SERVICE INFORMATION NO. SI 42-145

All DA 42 airplanes equipped with Thielert TAE 125-01 engines

Update of TAE Repair Manual RM-02-01 Issue 4 Revision 7
ATA-Code: 72-10

Fig. 05.0.5

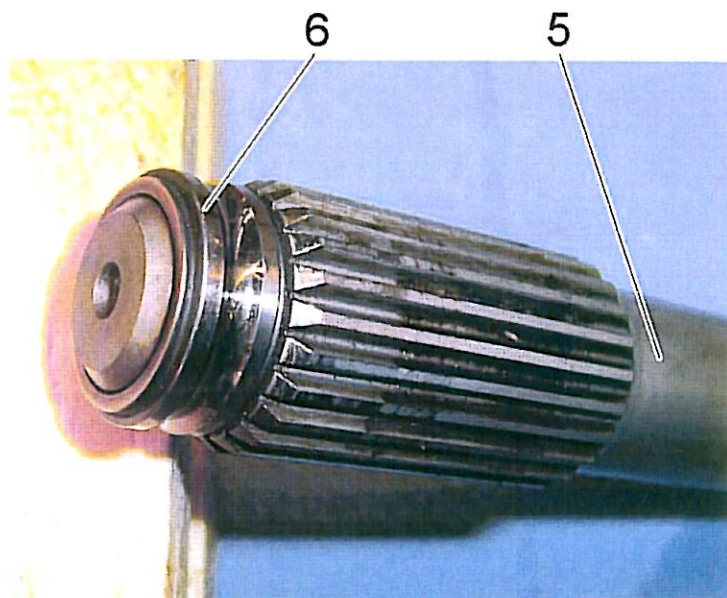
6. Remove the clutch shaft (item 5) and the clutch shaft bearing (item 6). Pay attention to cleanliness! Discard the clutch shaft (item 5) and the clutch shaft bearing (item 6) and replace them with new ones during re-assembly.
7. Fit the new clutch shaft bearing (item 6) to the clutch shaft (item 5). See Fig. 05.0.5.

■ **CAUTION:** Make sure that the bearing is fitted correctly to the clutch shaft.

■ **CAUTION:** Always ensure that the clutch shaft is installed dry and free of grease.
The use of ceramic spray is not permissible!
Disregarding these instructions may cause the clutch to fail.
